**CITY OF ST. HELENS PLANNING DEPARTMENT
STAFF REPORT**

Subdivision Preliminary Plat, **SUB.1.25**
Subdivision Variance, **V.1.25**
Sensitive Lands Permit, **SL.1.25** (significant wetlands)
Sensitive Lands Permit, **SL.2.25** (steep slopes)
Sensitive Lands Permit, **SL.3.25** (drainageways)

PROPOSAL: 66 lot Planned Development Subdivision Preliminary Plat

Boulder Ridge Subdivision

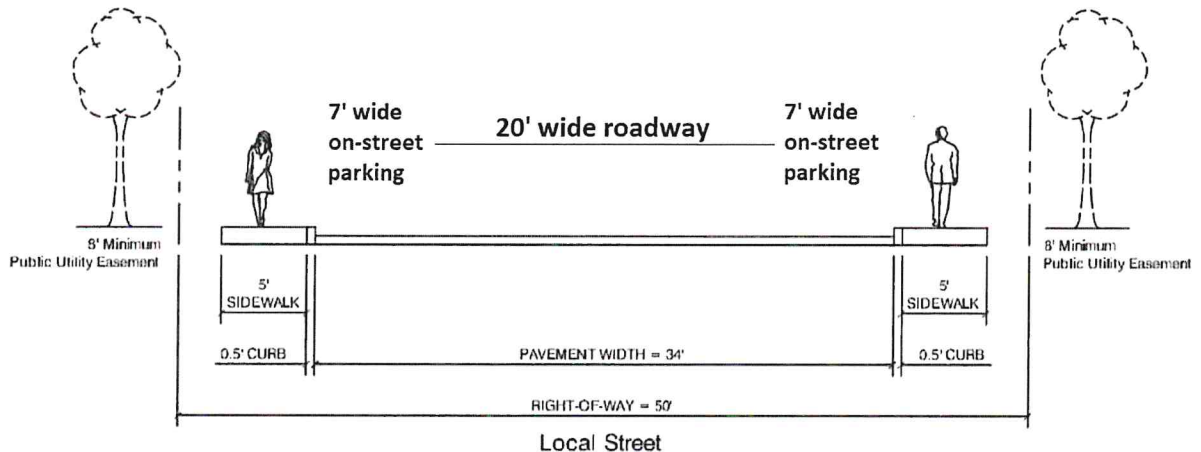
CFFR provided comments for this 2025 effort, noting the limited access concerns and the complications that poses in the emergency event, street parking concerns and cul-de-sac standards concerns.

- Limited access concerns.

- Street parking concerns. **This is something for the Commission's consideration.**

- Cul-de-sac standards

OVERALL STRIPING AND SIGNAGE PLAN
SCALE: 1" = 50'-0"

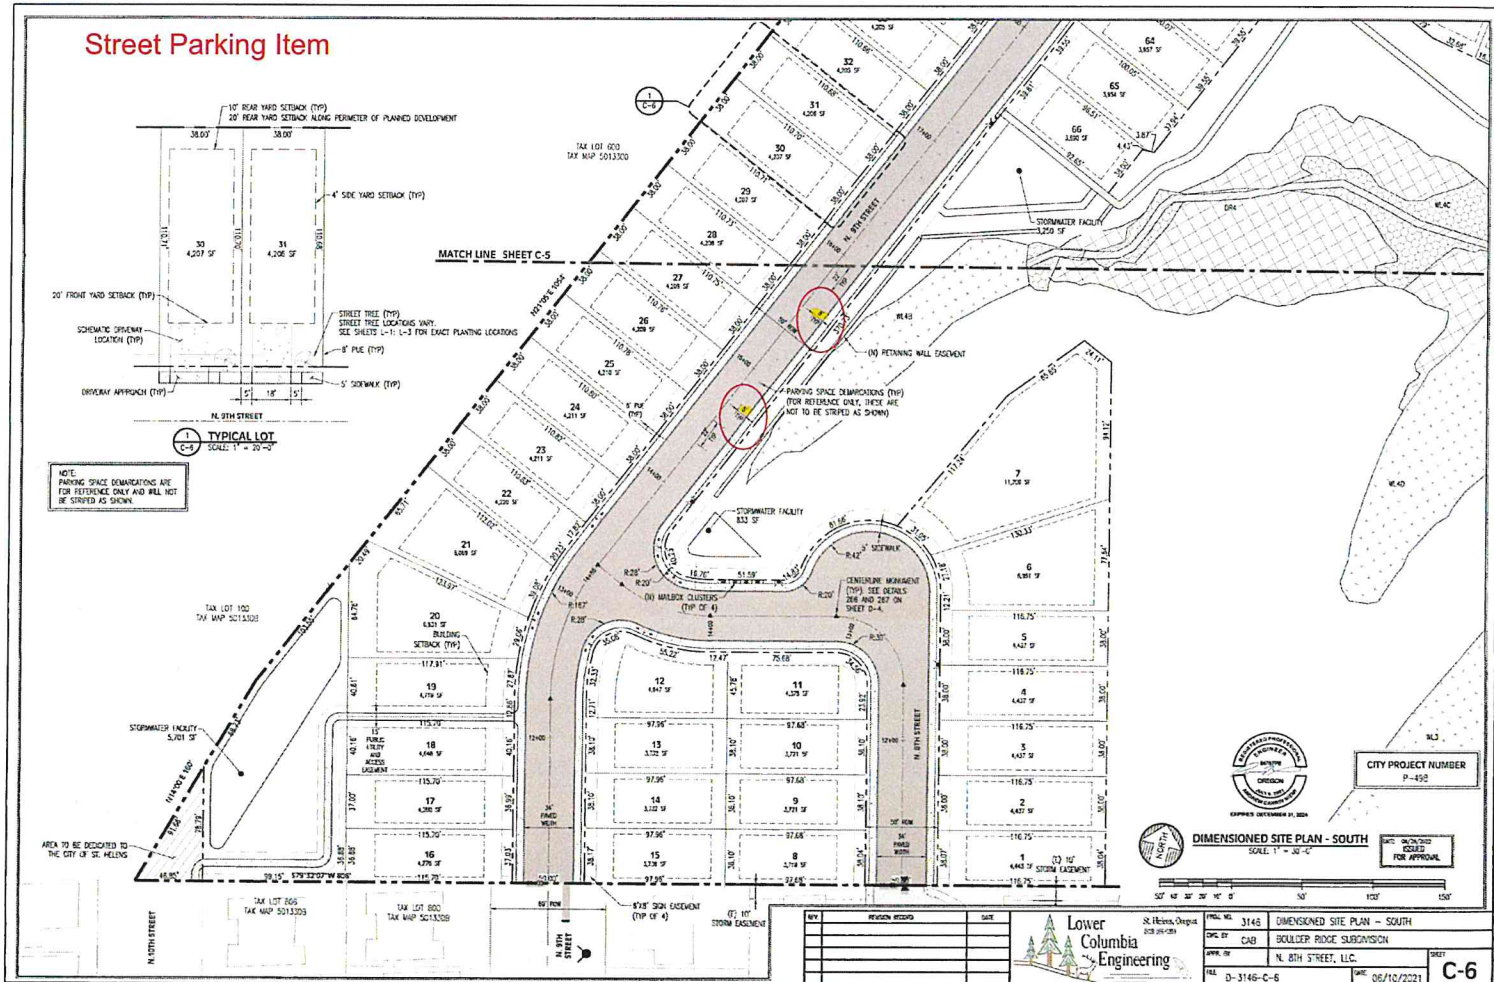
- There needs to be a blended transition to existing pavement on N 9th Street to connect to the proposed street limits. The existing street pavement is slightly skewed and is not in the middle of the Right of Way Limits on N 9th Street. The Public Improvements Plans do not account for this pavement transition, and more details need to be provided. The N 8th Street pavement does not require a transition segment.
- The Fire Marshall stated some concerns regarding clear width along the drive isles. The 34-foot paved cross section supports 20' of clear travel lanes and 7' for on-street parking on both sides. The plans show 8' parallel parking spaces which reduces the 20' of clear travel lane width to 18'. To meet the 20' clear width requirement, there needs to be additional areas striped for No Parking for fire access or revise the parking width to be 7'.

Street Parking Item

Street Parking Item

Additional No Parking Striping required if driveway access isle is not met.

AREA WHERE CURB TO BE PAINTED YELLOW FOR FIRE LANE/NO PARKING

AREA CONNECTIVITY

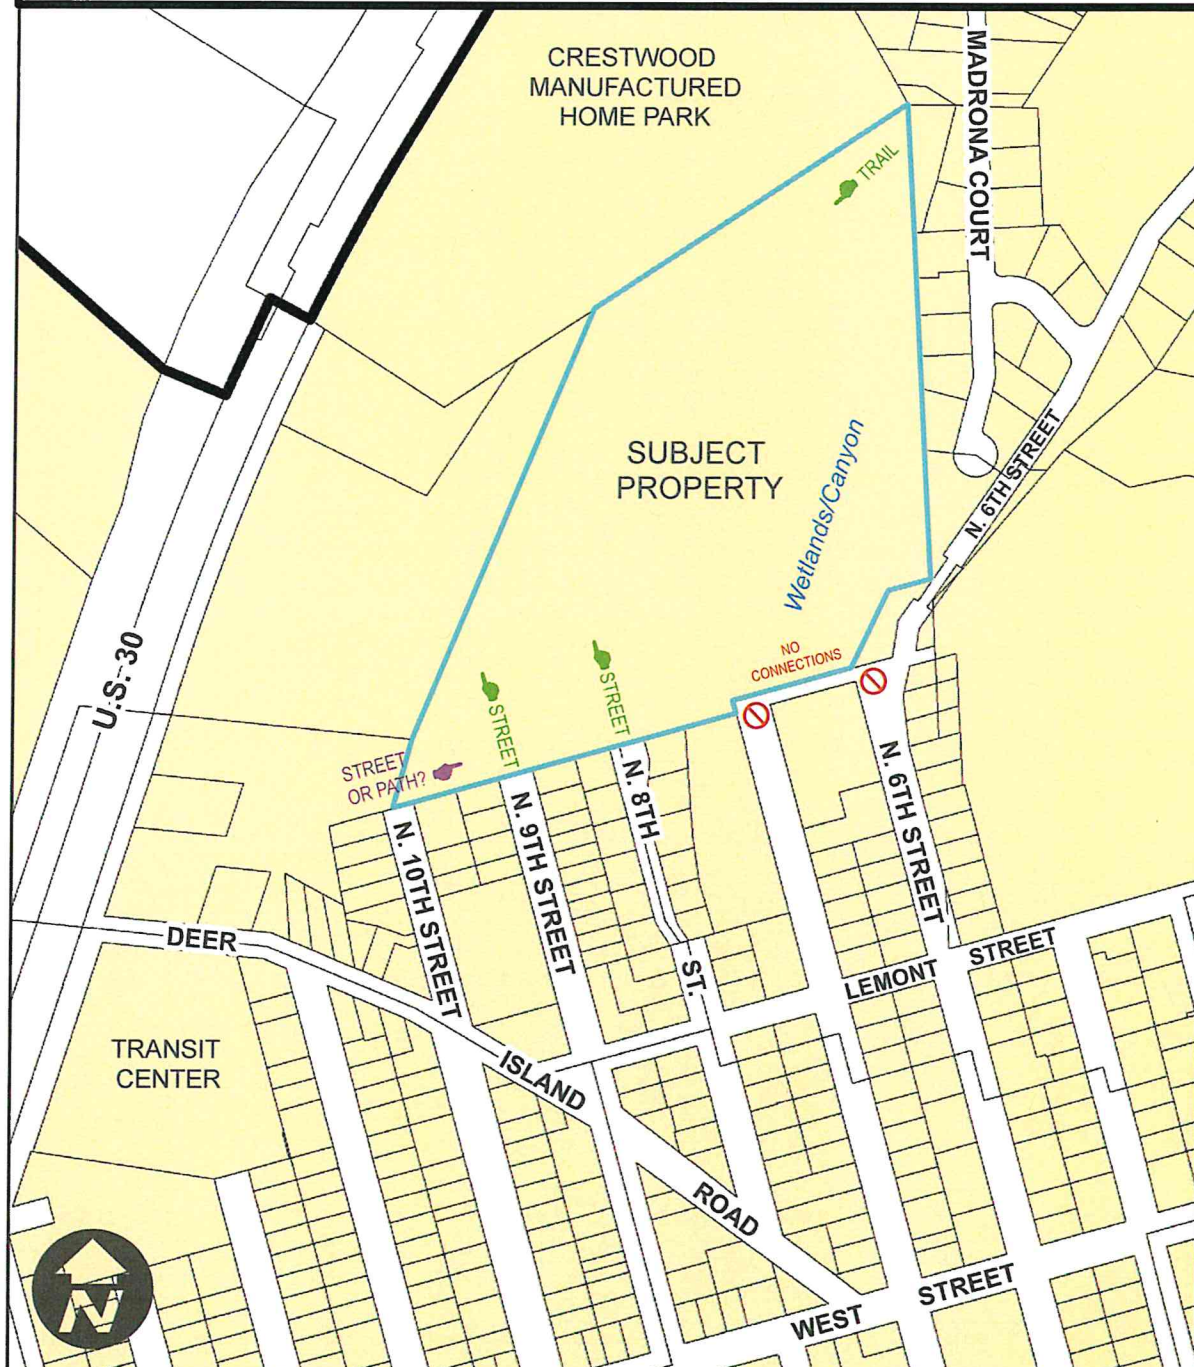
As the Planning Commission considers the developed streets between the subject property and Deer Island Road, N.10th Street should not be overlooked. Also see Exhibit D.
